METROPOLITAN COAL LONGWALLS 305-307

**LONGWALL 307
EXTENSION SUBSIDENCE REVIEW REPORT**

Ref: MSEC1091 Revision A

**RE: Metropolitan Mine – Modified commencing end Longwall 307
Mine Subsidence Overview**

Fig. 1

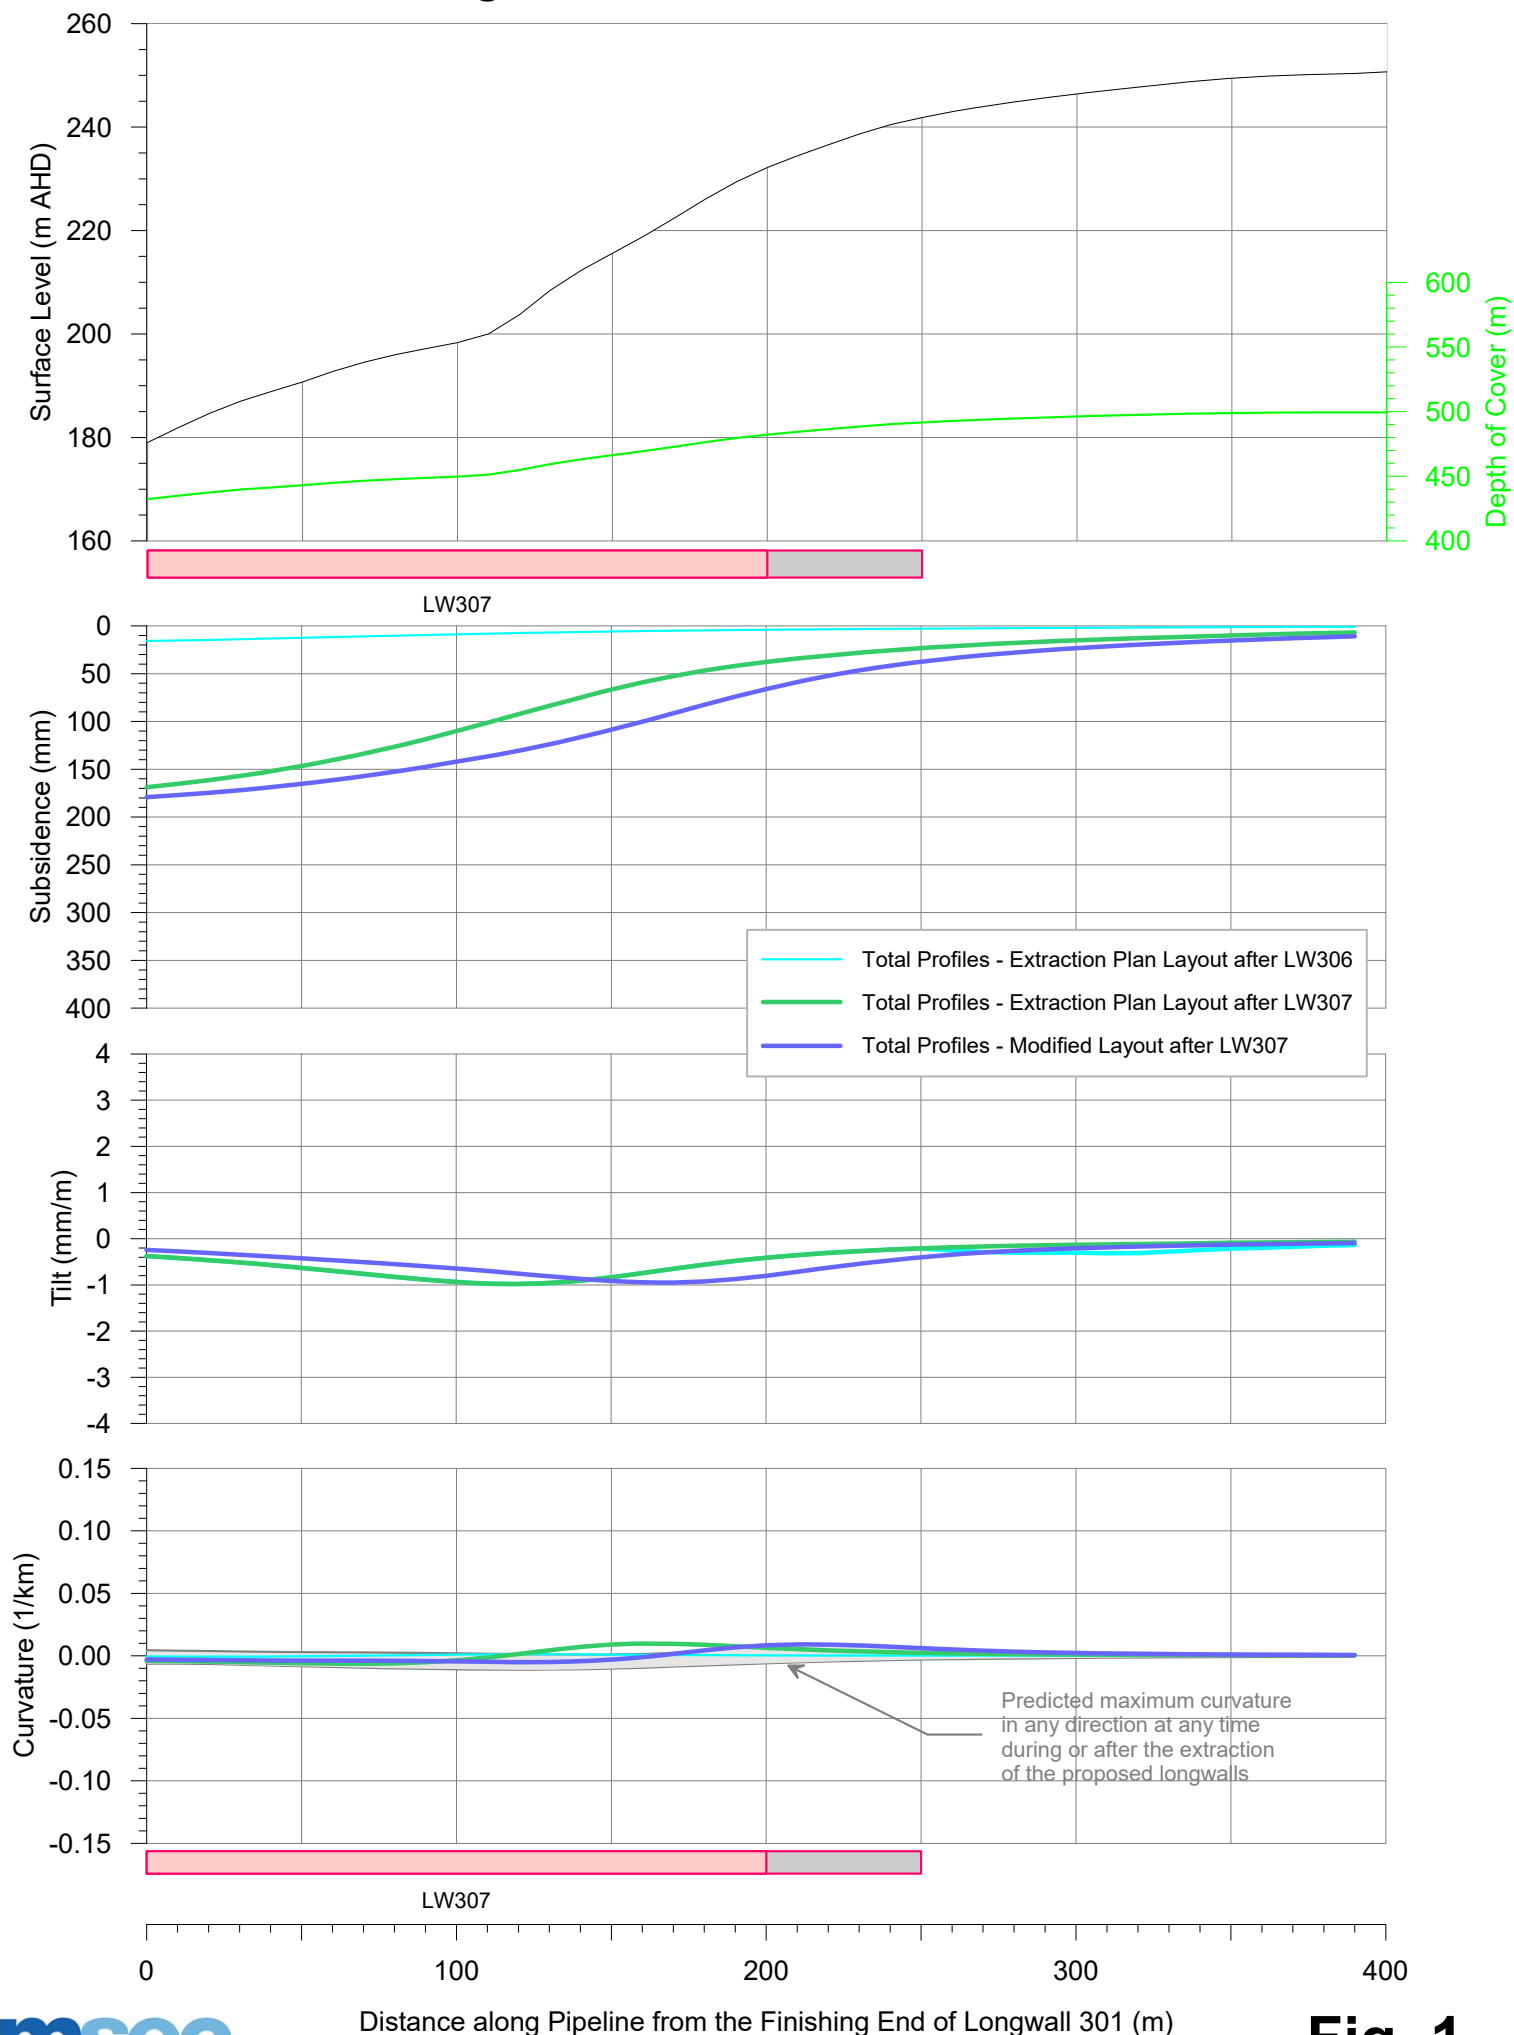
Similar to the maximum predicted vertical subsidence, the maximum predicted total tilt, curvatures and strains due to the extraction of Longwall 307 do not change due to the proposed modification. However, the locations of the longitudinal components of these parameters (i.e. orientated along the main longwall axis) move towards the north. This is illustrated in Fig. 1 and Fig. 2 which shows the predicted profiles of total vertical subsidence along Prediction Line 1 and Water Main 1. The location of prediction Line 1 is shown in Drawings Nos. MSEC1154-01 to 03.

The predicted tilts curvatures and strains for the natural and built features within the Study Area based on the Modified Layout decrease for some features and increase for other features depending on the location of the surface features.
